KRONICK
MOSKOVITZ
TIEDEMANN
& GIRARD

May 28, 2026

Re: Allocating responsibility to achieve sustainability in 5-year Evaluation of GSP for Salinas Valley's 180/400-Foot Aquifer Subbasin

FIGURE 1
Historical & Aquifer Full Baseline Maps
Superposition Model Testing

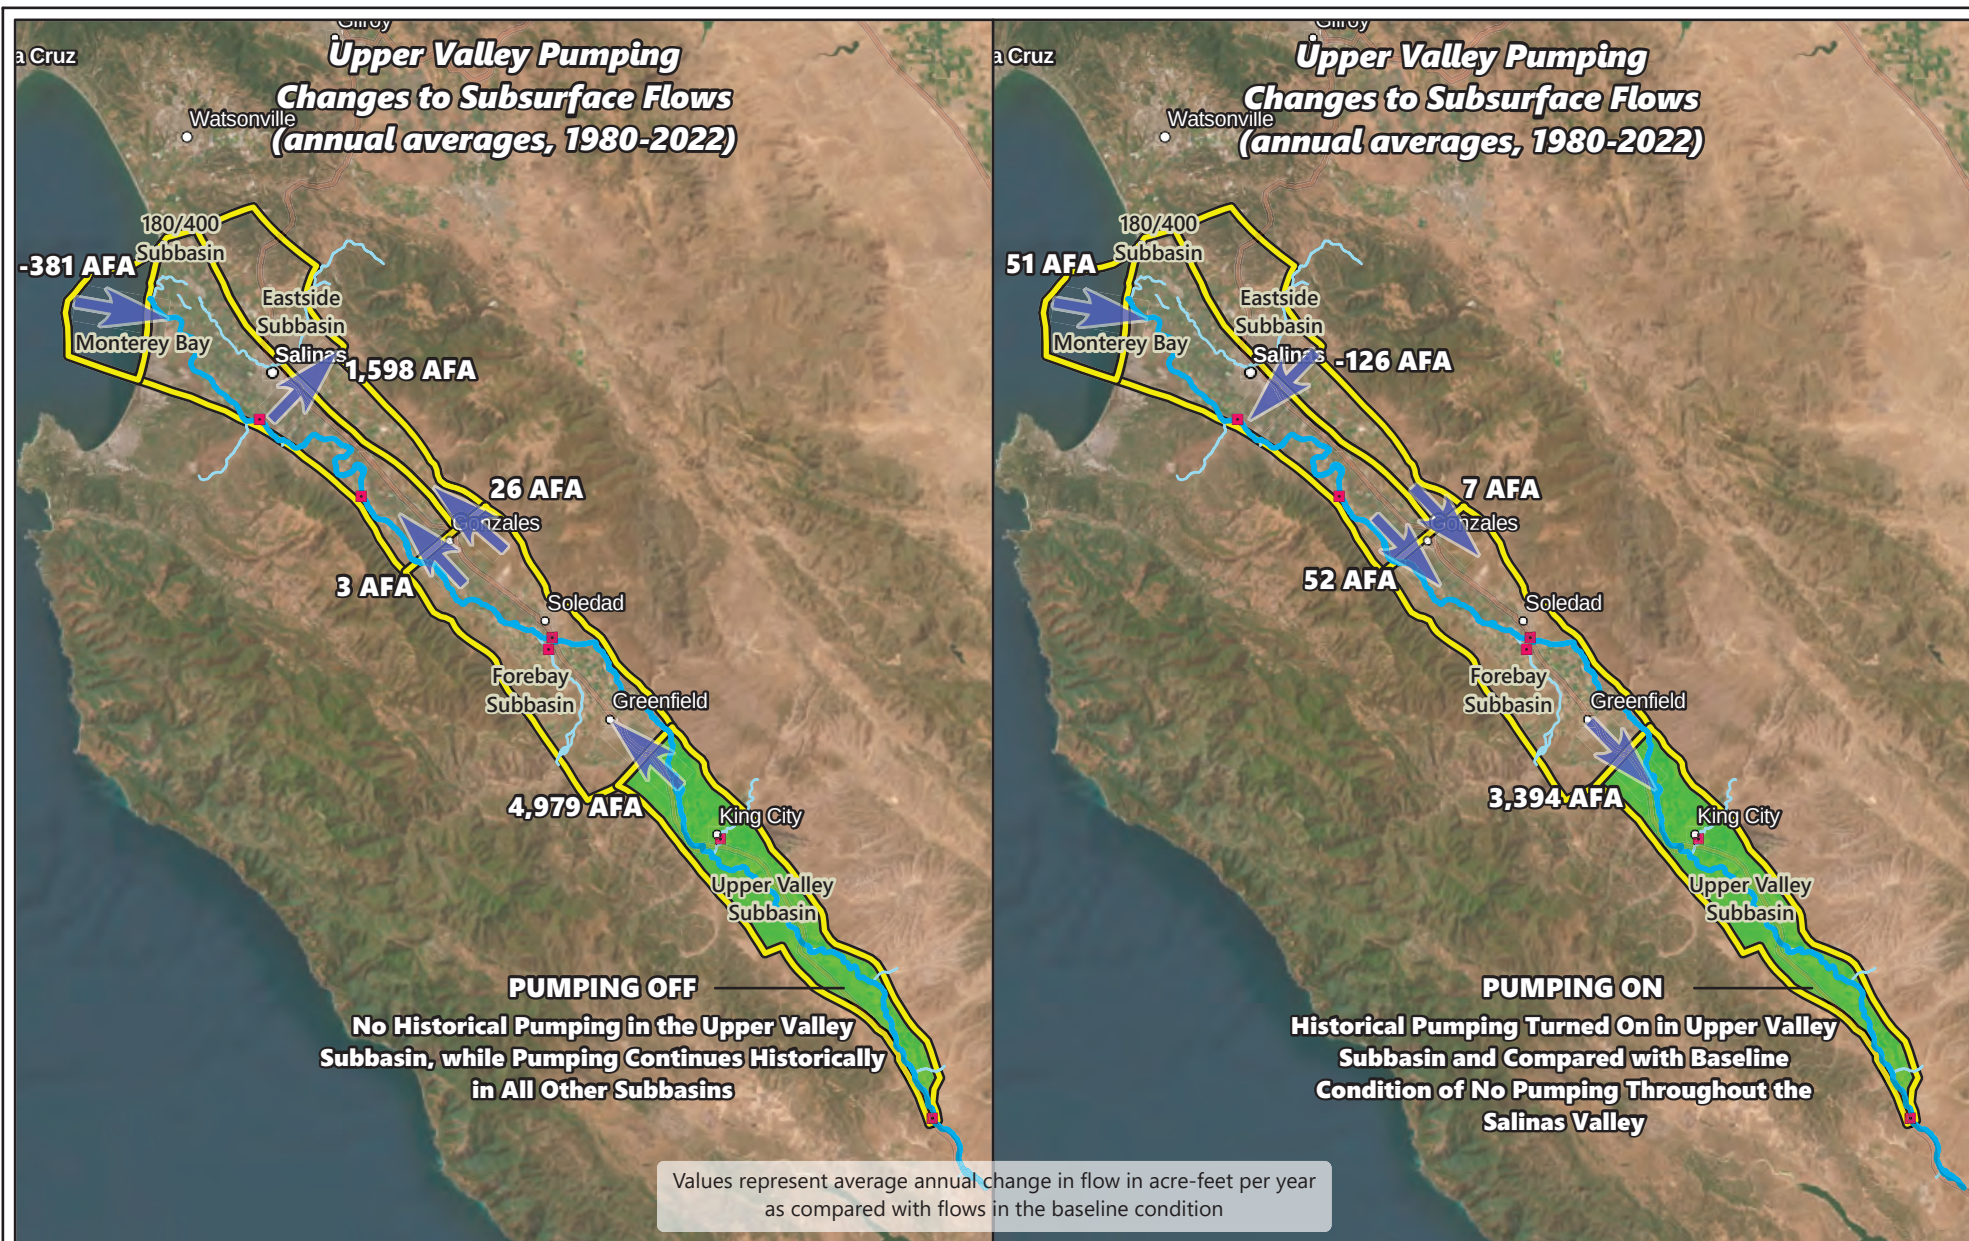
Figure 1 illustrates the model simulated subsurface flows between the Upper Valley, Forebay, Eastside and 180/400 subbasins for the two baseline conditions from which superposition testing is compared. The left pane shows the simulated average annual subsurface flows between subbasins that has historically occurred. The right pane shows the simulated subsurface flows between subbasins for a baseline condition where no pumping has occurred in any subbasins. All values are in units of acre-feet per year (AFA) as averaged over the modeled years of 1980-2022. Under the historical baseline, an average of 5,071 AFA flows from the Upper Valley to the Forebay Subbasin; 8,431 AFA flow from the Forebay to the 180/400 Subbasin, and 6385 AFA flows from the Forebay to the Eastside Subbasin; 27,292 AFA flows from the 180/400 to the Eastside Subbasin; and 8603 AFA flows from the bay into the 180/400 Subbasin as seawater intrusion.

FIGURE 2
Upper Valley Pumping
Superposition Model Testing
Salinas Valley, CA

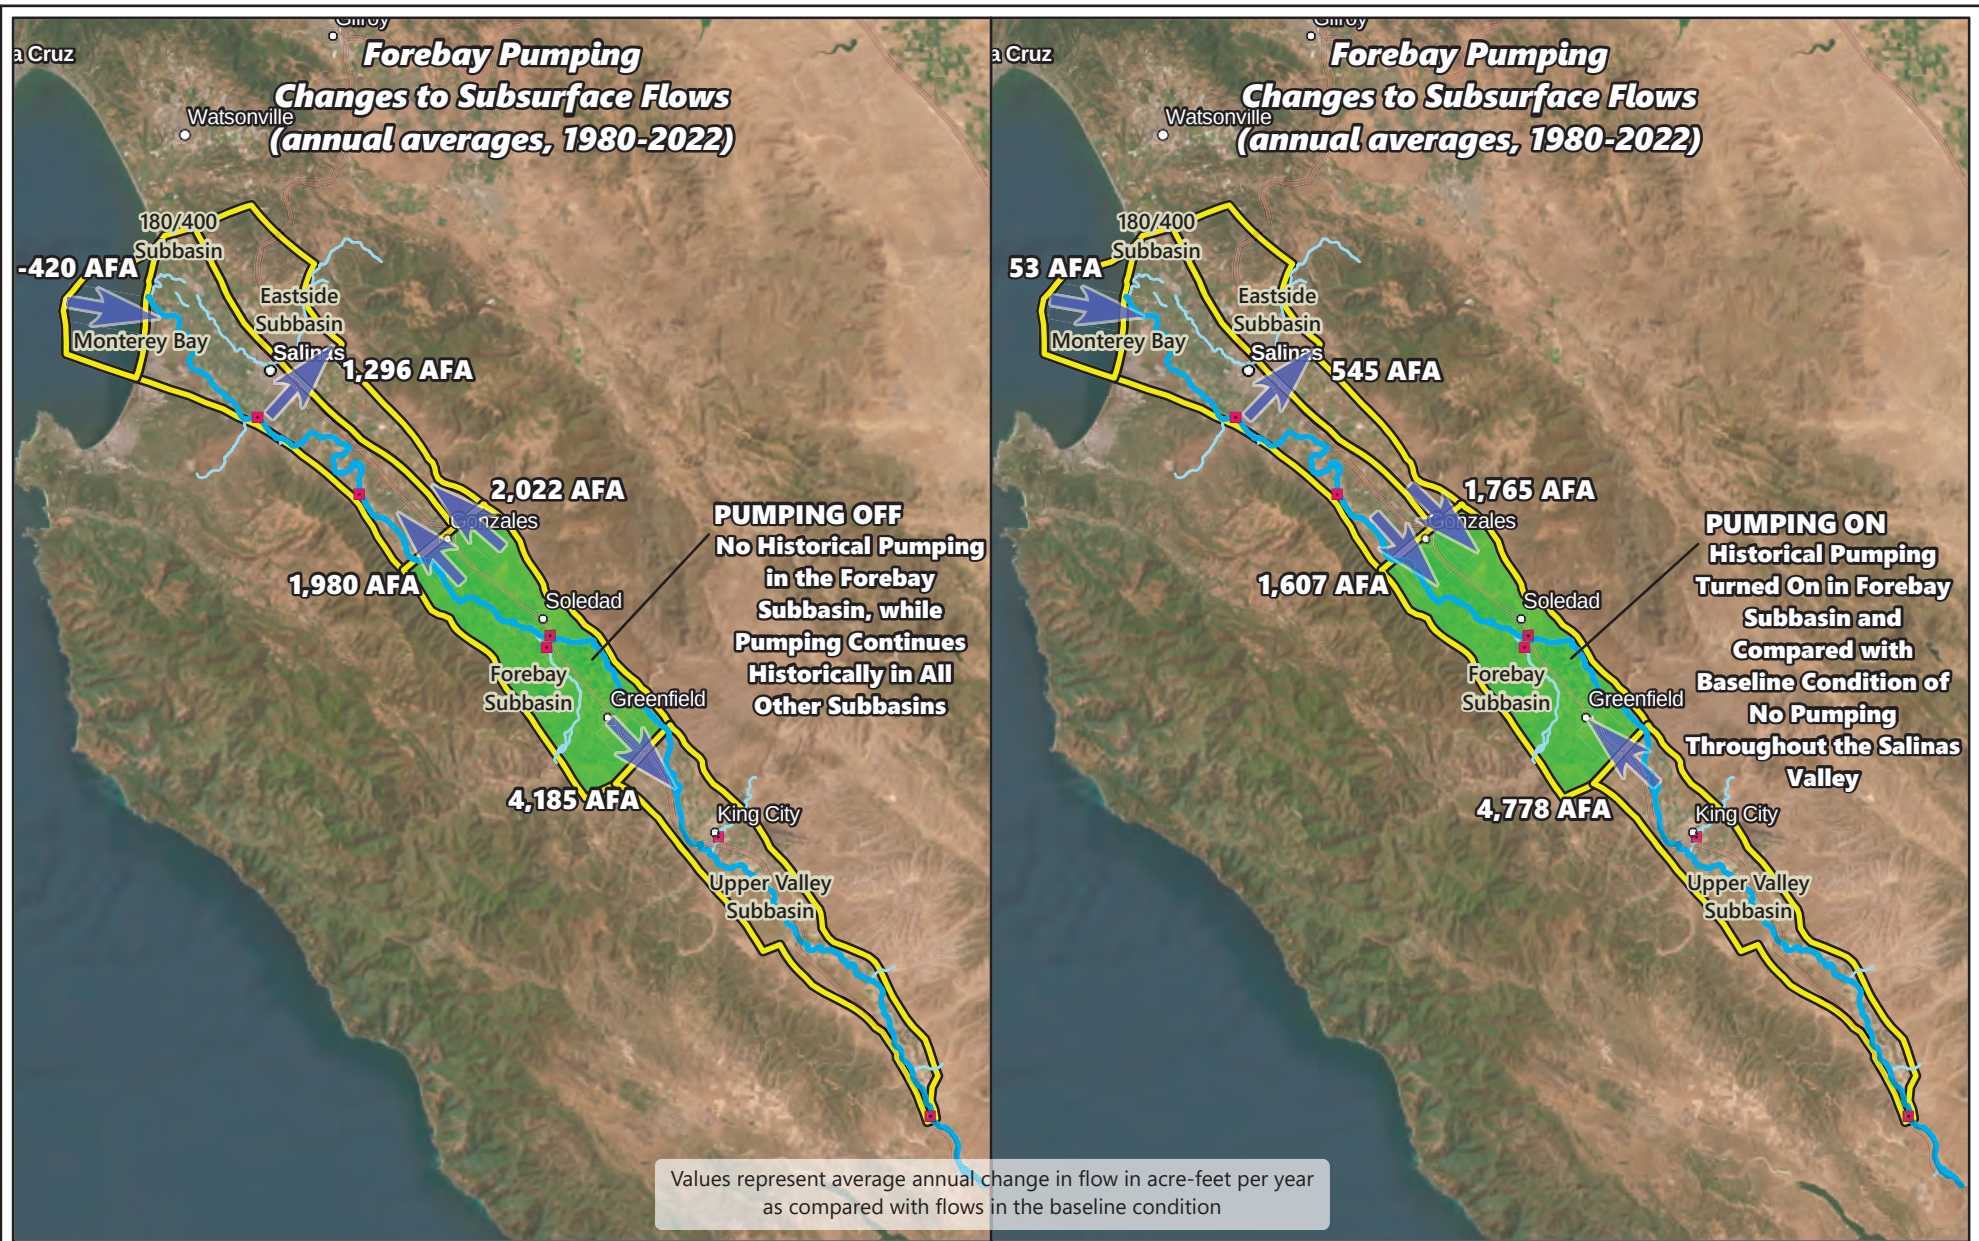
The **Figure 2** left pane illustrates how much the subsurface flows are simulated to change if there had been no pumping from the Upper Valley Subbasin over the entire historical period. There is a simulated increase in subsurface flow from the Upper Valley to the Forebay Subbasin of 4,979 AFA; a simulated increase in subsurface flow from the Forebay to the 180/400 and Eastside Subbasins of 3 and 26 AFA, respectively; a simulated increase in subsurface flow from the 180/400 to the Eastside Subbasin of 1,598 AFA; and a reduction in seawater intrusion to the 180/400 Subbasin of 381 AFA. The changes under the "full aquifer" baseline where the starting point is no pumping anywhere in the valley, then pumping is

FIGURE 6
Historical & Aquifer Full Baseline Maps
Superposition Model Testing

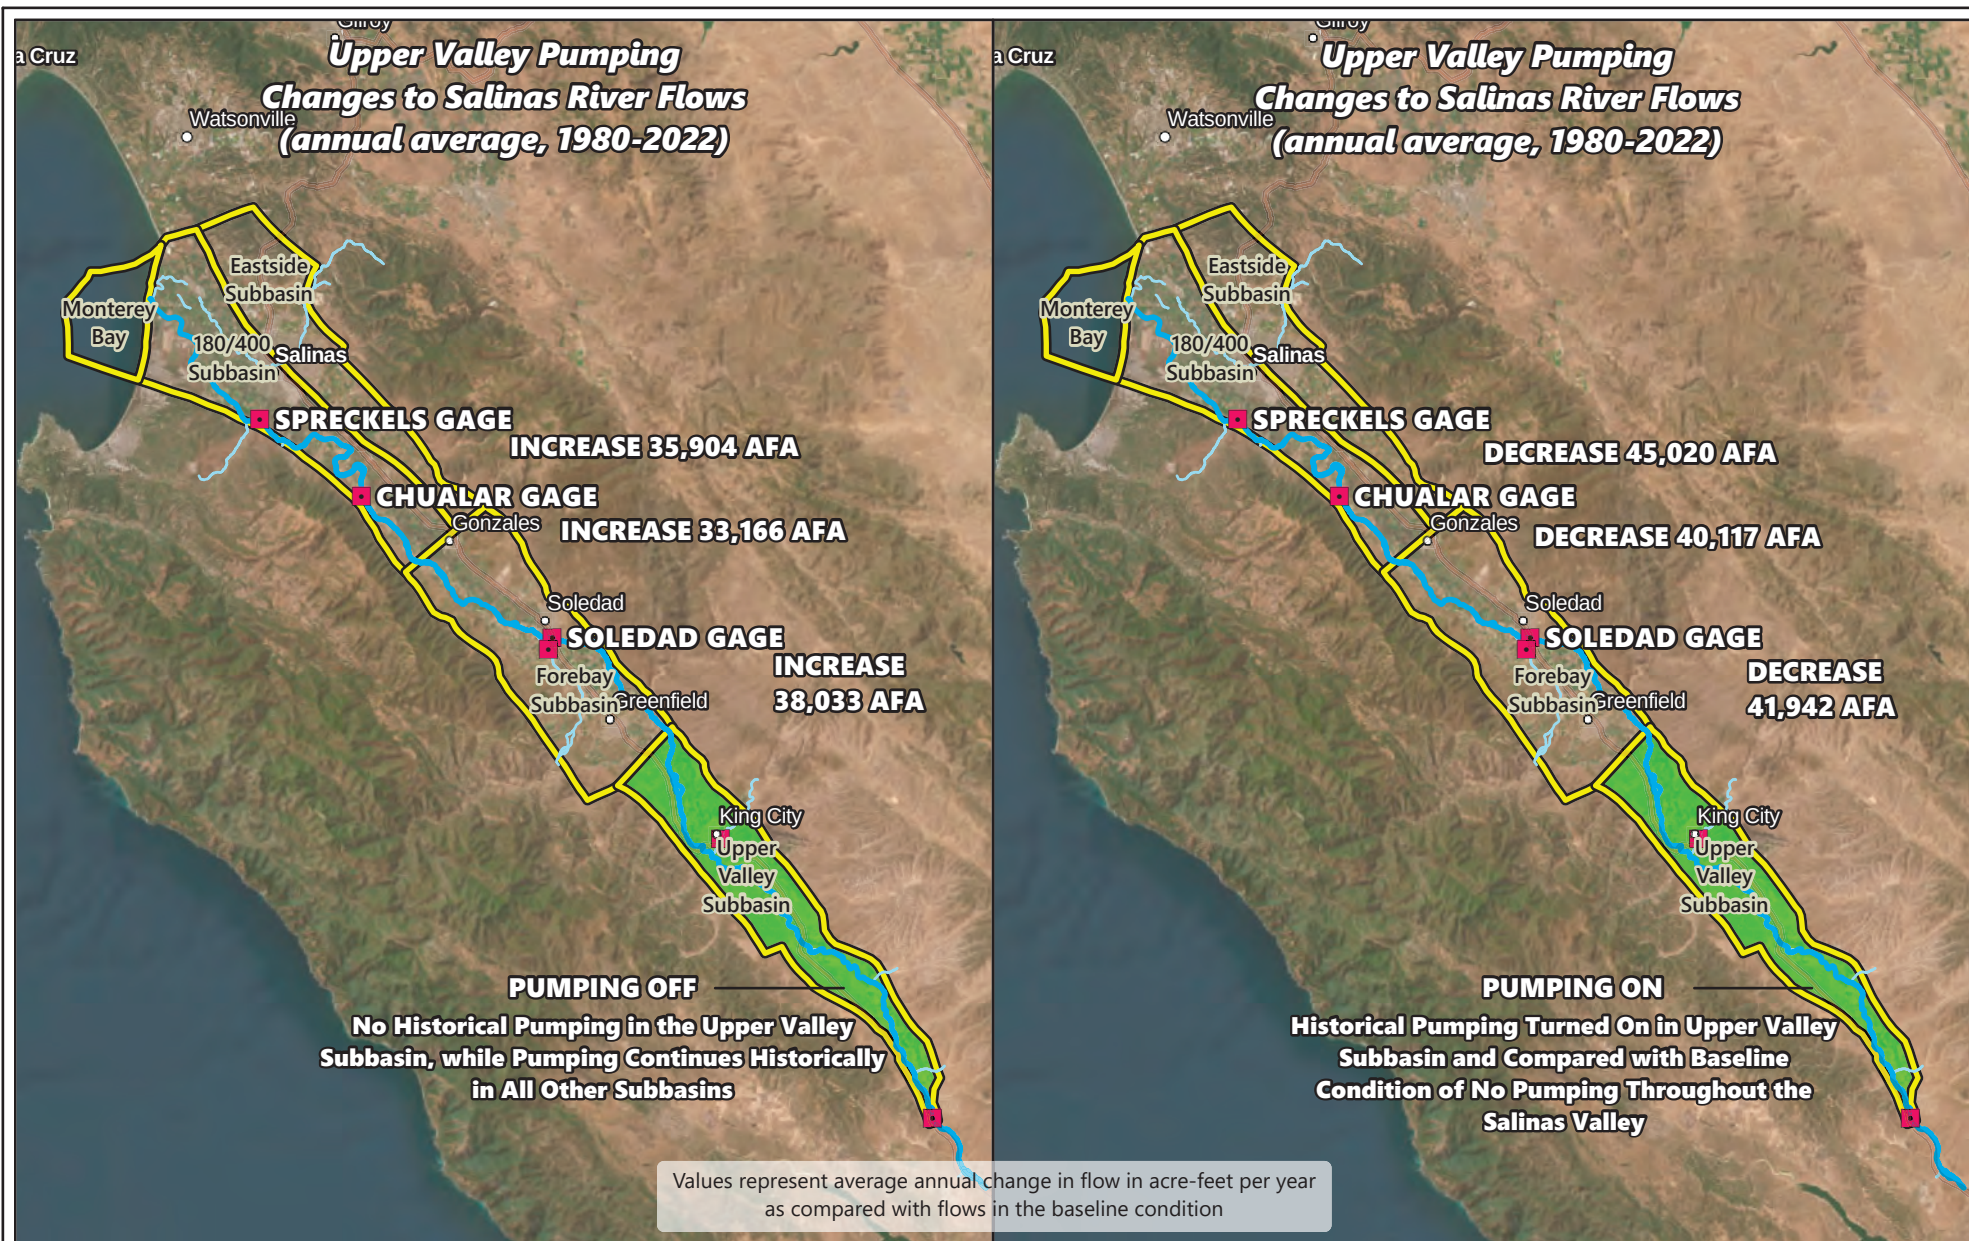
For example, Salinas River average annual flow at the Spreckels gage for historical pumping baseline is simulated at 246,536 AFA (left pane, **Figure 6**). When all historical pumping in the Upper Valley Subbasin is turn off for the simulation period, there is an increase in average annual flow at the Spreckels gage of 35,904 AFA (left pane, **Figure 7**), or an approximate flow increase of 14.6% (**Table 5**). For the “full aquifer” baseline conditions, historical pumping turned on in the Upper Valley Subbasin is simulated to decrease the average annual flow at the Spreckels gage from 423,519 AFA to 378,498 AFA, or a reduction in flow of 45,020 AFA or 10.6% of the total annual flow at Spreckels (refer to **Figure 7** right pane, and **Table 6**).
